**BEFORE
THE OHIO POWER SITING BOARD**

In the Matter of the Application of)	
Kingwood Solar I LLC for a Certificate)	Case No. 21-0117-EL-BGN
of Environmental Compatibility and)	
Public Need)

**KINGWOOD SOLAR'S JUNE 1, 2021 RESPONSES
TO STAFF'S MAY 17 AND MAY 20 DATA REQUESTS**

Figure 04-1
Solar Resource Map of Ohio

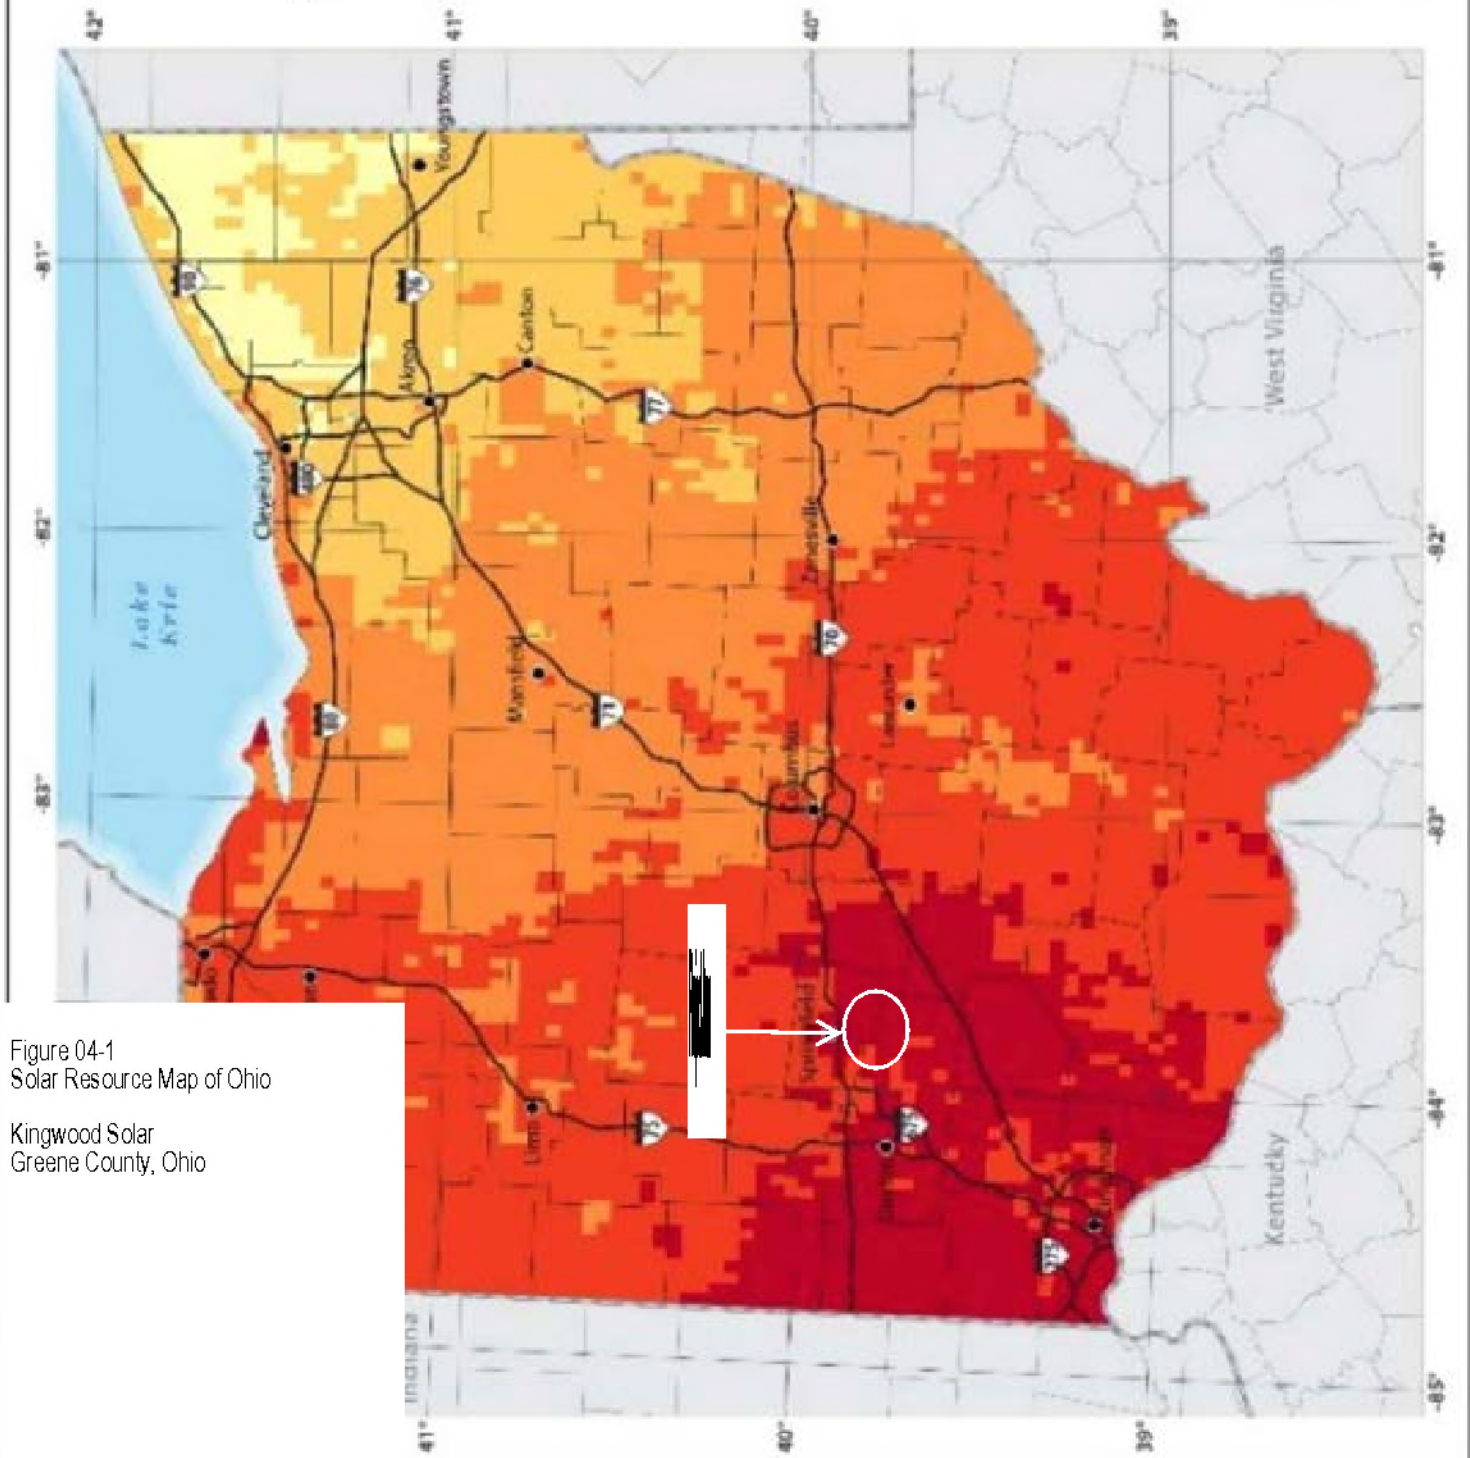
- 12. The electronic version of Figure 04-1 filed in the PUCO docketing information system is difficult to read. Please provide a clean and easy to read version of Figure 04-1.***

A revised copy of Figure 04-1 is attached. As shown, the Project Area is located in the southwestern portion of Ohio, which receives the most direct solar resources within the state.

Figure DR1-13
Layout Constraint Considerations
Sheet 3 of 9
Kingwood Solar
Greene County, Ohio

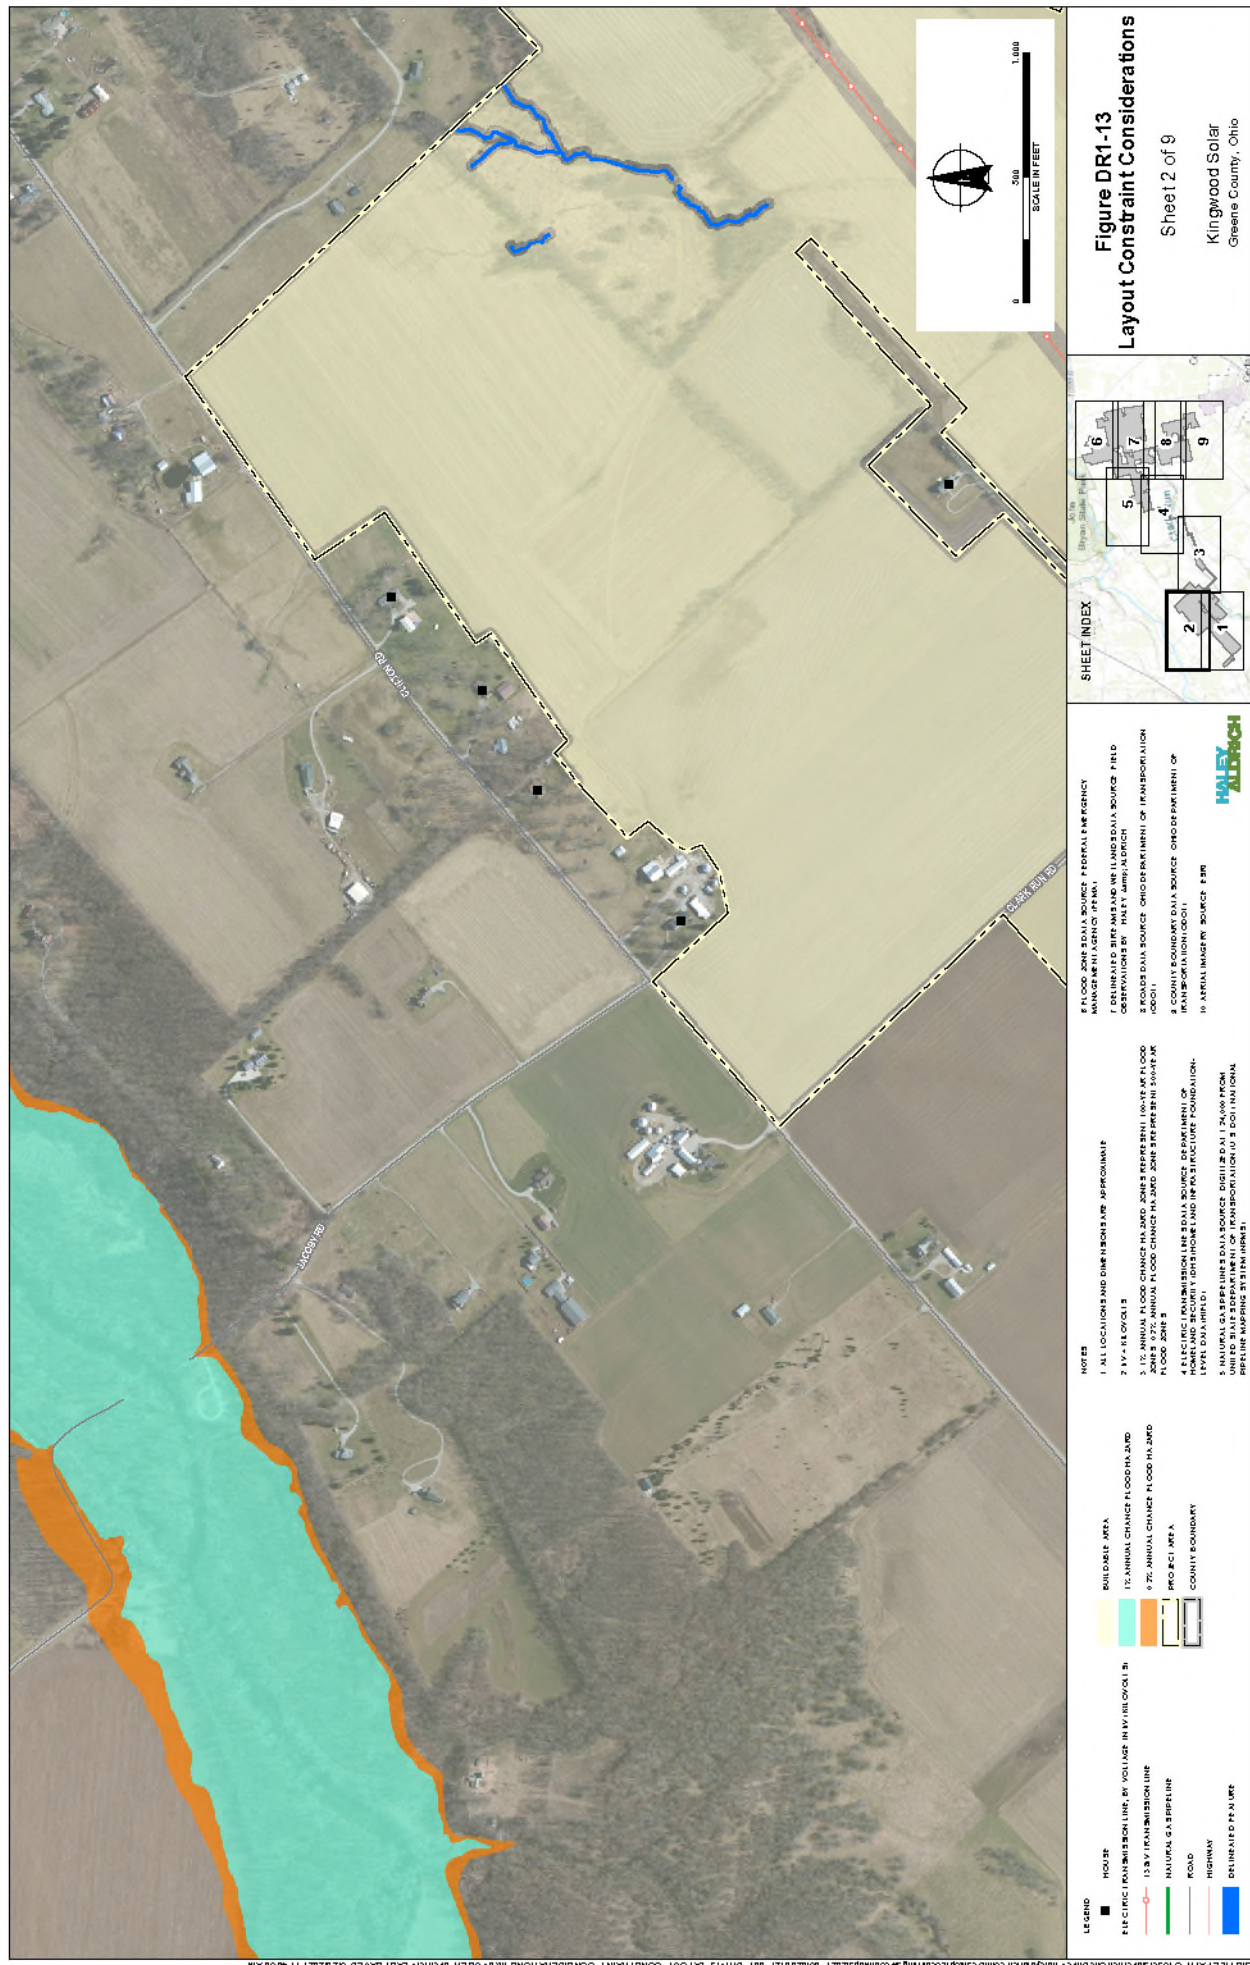
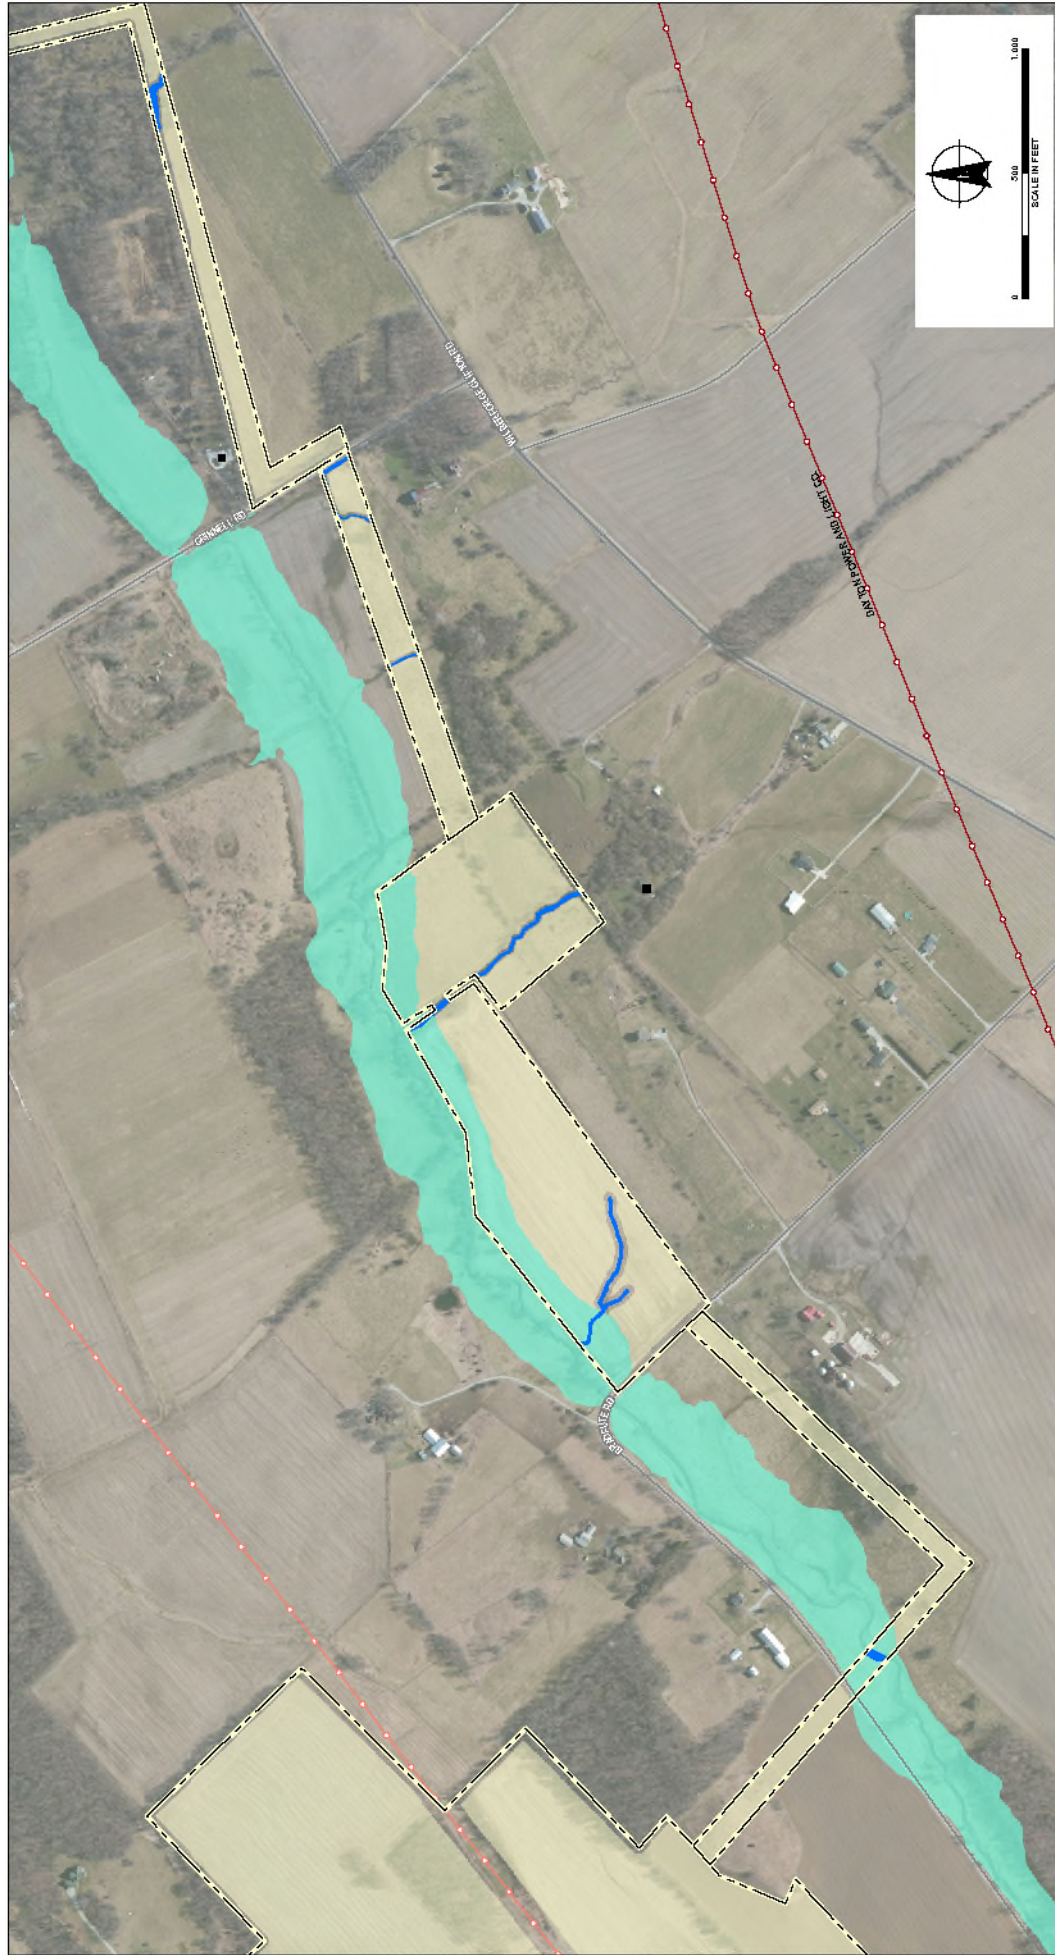
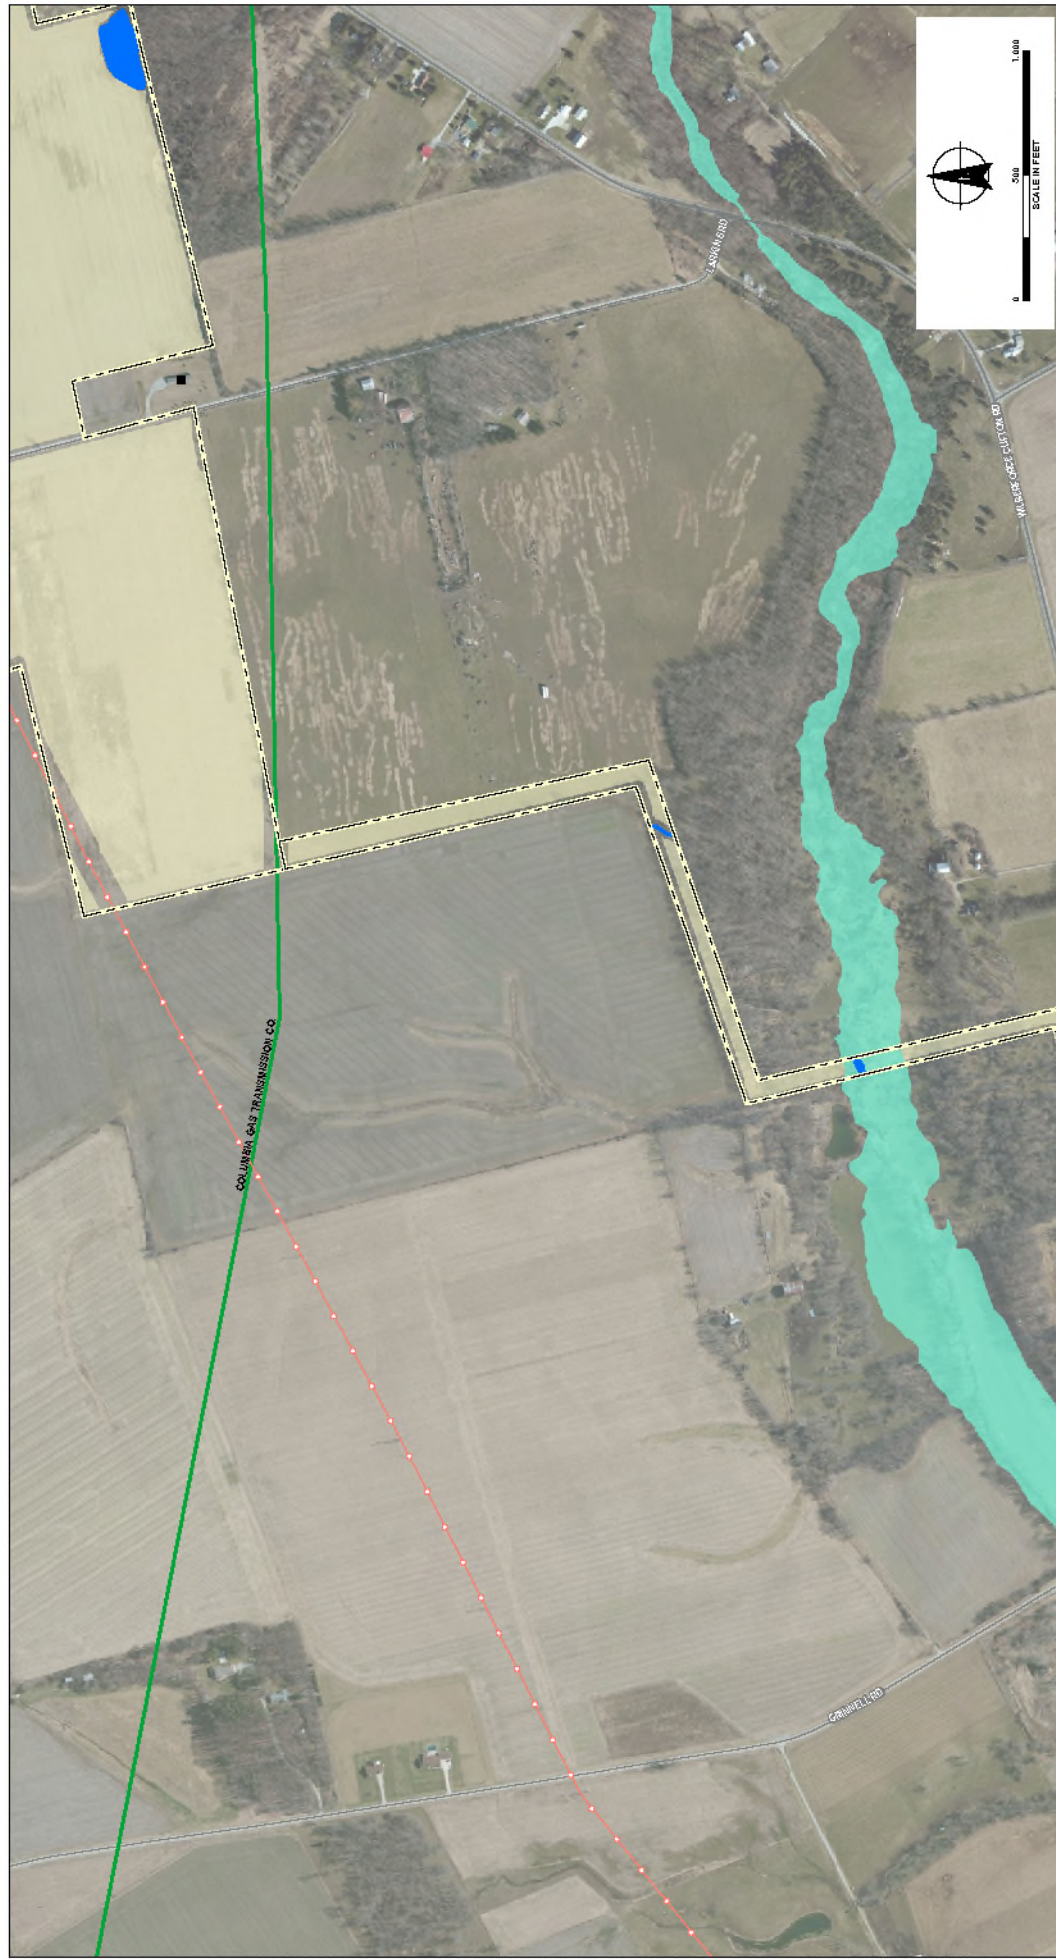
- 13. Figure 04-2 does not show setbacks from residences, property lines, utility corridors, and public rights-of-way, and any other constraints of the site design. Please provide a map that provides a constraint map showing setbacks from residences, property lines, utility corridors, and public rights-of-way, and any other constraints of the site design.***

12. Please provide a buffer layer(s), in the form of shapefiles or .KMZ, of any setbacks applied to the project.

Figure DR1-13 illustrates the constraints considered for the Project layout. This map is intended to show the maximum extent of potential solar array areas while avoiding existing public rights-of-way and existing easements (utility corridors), with a minimum setback from abutting property lines of 25 feet.

A shapefile package outlining the buffers around identified constraints is attached. In responding to this question, an error was identified on Figure DR1-13, which was provided with the responses to Data Request Set 1. A revised version of this figure is attached correctly illustrating a consistent 25-foot setback from the Project Area boundary. The shapefiles were also revised accordingly.
